CITY OF BOULDER CITY COUNCIL AGENDA ITEM

AGENDA TITLE: Concept Plan review and comment on planned redevelopment of the property located at 1313 Broadway. Proposed is a 198-room hotel along with ground floor retail, co-working office space, plaza space and below grade parking within the University Hill Business District. Reviewed under case no. LUR2020-00004.

AGENDA TITLE: CONCEPT PLAN & REVIEW for a redevelopment of the property located at 1313 Broadway. Proposed is a 198-room hotel along with ground floor retail, co-working office space, plaza space and below grade parking within the University Hill Business District. Reviewed under case no. LUR2020-00004.

REVIEW TYPE: Concept Plan Review & Comment

Figure 20: Existing Sanitary Sewer Infrastructure (shown in green) superimposed onto plan

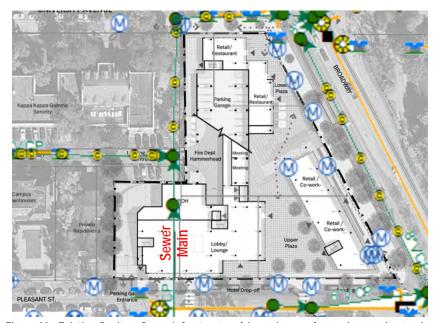
Engineering and Site Design Considerations. As shown in Figure 20 below, the subject site is currently impacted by an active sanitary sewer main oriented in a north/south alignment, approximately bisecting the existing UHGID parking lot. The sanitary sewer main is located within an existing narrow public right-of-way and adjacent public utility easement. It may be possible to abandon a portion of the sanitary sewer main and vacate both the public right-of-way and public utility easement if it is determined that there is no public need for that facility specific to the present location. However, to make a determination that no public need exists, it would be necessary to show a new sanitary sewer main could be constructed in an alternate alignment in order to maintain the City's sanitary sewer collection network. During initial review of the current concept, staff noted that the applicants' proposal for relocation of the sanitary main to an east/west alignment in Pleasant Street would be challenging given the high concentration of existing public and private utilities within the Pleasant Street right-of-way. The abandonment of the existing sanitary sewer main, and the ability to relocate that infrastructure is critical to the hotel configuration as it is shown in the Concept Plan today. Staff notes that if the abandonment of the existing facility and the sanitary sewer main relocation to Pleasant Street may be difficult to achieve and, in turn, cost prohibitive which would impact the current configuration and layout of the southwest side of hotel. Additional engineering investigation is critical and necessary to finalize the layout of the hotel.

Figure 26: The Varied Context and the Opportunity to Bridge the Character of the Surroundings

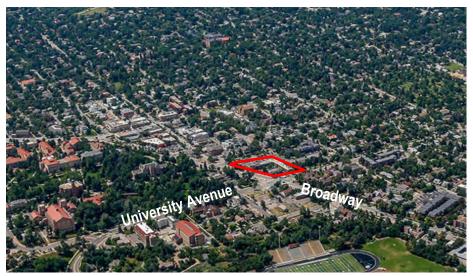
Given the eclectic nature of the surroundings, it is arguable that there is no discernable consistent style, form, or building scale to emulate. In that sense, the site is an opportunity to be a transitional bridge between the grander collegiate mass and scale and the organically evolved mercantile style of the hill. The planned hotel with a varied building mass and scale, and modulated building forms that are grounded with a strong pedestrian-engaged street level, does manage the bridge. As

project plans progress to Site Review, greater definition of finish materials and fenestration will also help to bridge the varied context.
